# WARRANTY BULLETIN QUALITY

Subject: **Spyder® RT - Abnormal Gaps Around the Rear Cargo Module Access Covers**

No. **2020-4**

**REVISION 1**

rbg2020-002-010

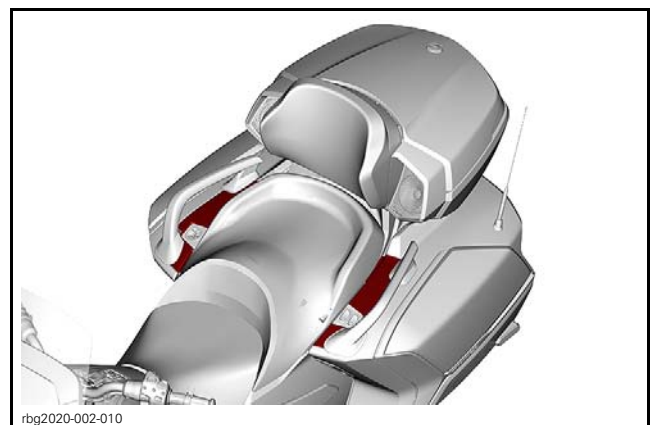
On some Spyder RT manufactured since February 6<sup>th</sup>, abnormal gaps may be present between both rear cargo module access covers and adjacent body parts.

Replace both access covers.
